Revisions to Cells 8/21/19

Revisions to Area Pattern scales

SECTION THRU KEY

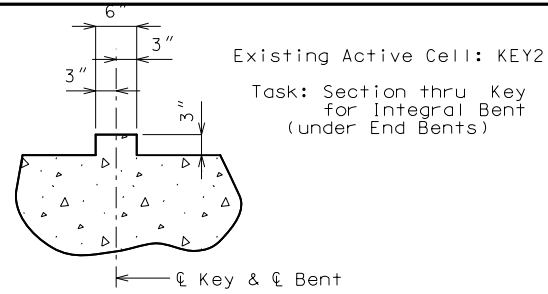
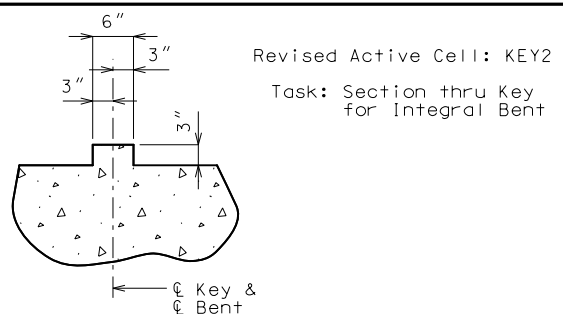
Revised To

TYPICAL SECTION THRU WING

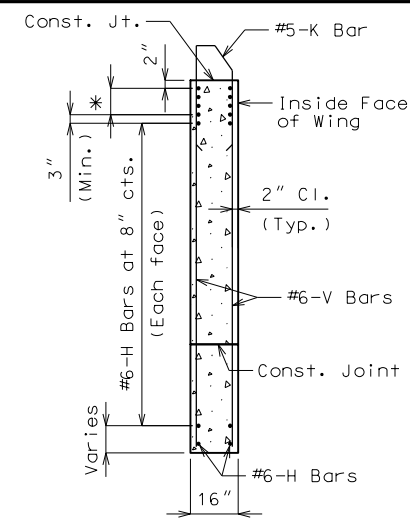
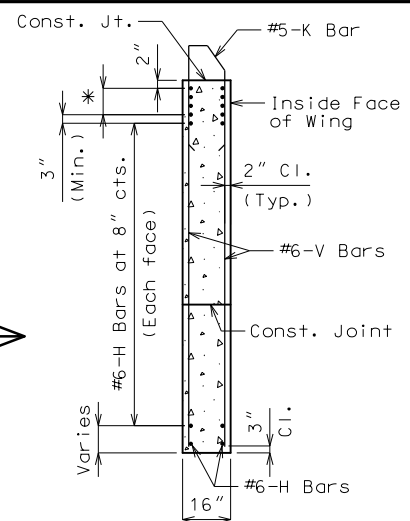
- Made these revisions to patterns under the Annotation category.
- Moved all patterns under the Annotation category directly under the Area Patterns Task. (Remove Annotation heading and all scale options)

Existing Rock Blanket Areafill  
Scale = 0.08333

Existing Concrete Areafill  
Scale = 0.00125

Existing Crosshatching/Hatching  
Spacing = 0.0017

Existing Steel Hatching  
Scale = 0.00087

Revised Rock Blanket Areafill  
Scale = 2.0000

Revised Concrete Areafill  
Scale = 0.0500

Revised Crosshatching/Hatching  
Spacing = 0.008

Revised Steel Hatching  
Scale = 0.003

ANCHOR SPLICES IN SPIRAL AROUND VERTICAL BAR  
(Use for intermediate splices of spirals)

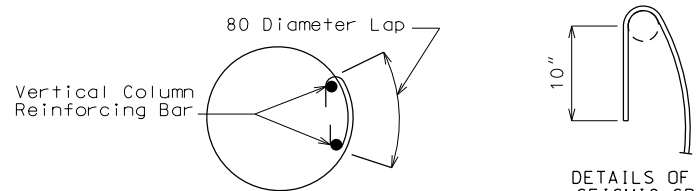
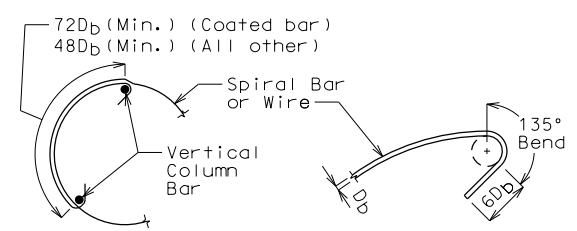
Existing Active Cell: SPIRA  
Task: Anchor Splice for Spiral Bar (under Intermediate Bents)

Revised Active Cell: SPIRA  
Task: Splice of Spirals

INTERMEDIATE SPLICE OF SPIRALS  
Standard 135-degree tie hooks that engage vertical column reinforcing bars shall be provided at each end of splice.

Tasks: (Prestressed Girders) P/S Box Beam 17", etc.

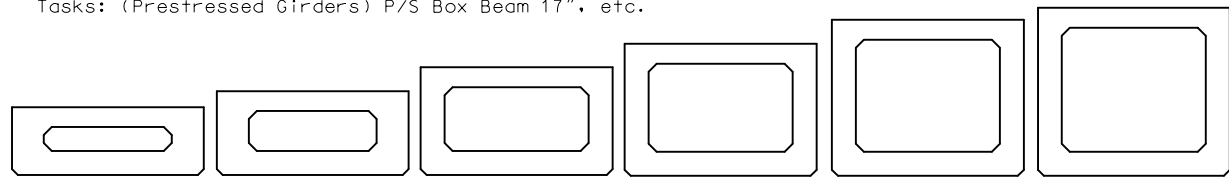
NEW
